Staff Report & Recommendation

Historic Preservation Board

HPB19-0341, 1751, 1757 & 1775 Collins Avenue.

The applicant has submitted plans entitled "The Raleigh Masterplan", prepared by Kobi Karp Architecture and Interior Design Inc., dated August 17, 2020.

Raleigh Hotel, 2016 Photograph (rooftop additions highlighted in red proposed to be removed)

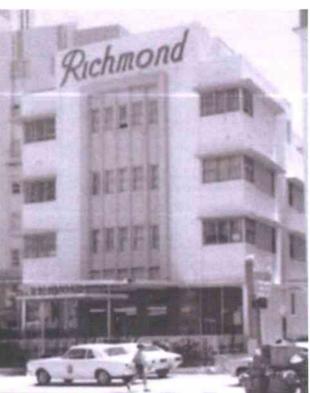
Additionally, as part of this submittal, an expanded scope of restoration is proposed including the removal of several inappropriate rooftop additions (see image below). These rooftop additions have an exceedingly adverse impact on the integrity of the original 1940 Dixon design and their removal will restore the skyline of the Raleigh Hotel to its former grandeur. Other notable restoration includes the reintroduction of a missing window within each set of ribbon windows along the broad curved corner of the building.

Staff is extremely supportive and enthusiastic of the expanded scope of restorative work. This additional scope in conjunction with the previously approved restoration will reposition the Raleigh Hotel as one of the most meticulously restored Streamline style hotels in the world.

- i. Consistent with the proposed plans, the following rooftop additions shall be removed: the 2-story penthouse, the 1-story enclosure at the southwest corner of the building, the 1-story enclosure at the north west corner of the building and a portion of the rooftop addition at the 8th level, in front of the north side of the tower element.
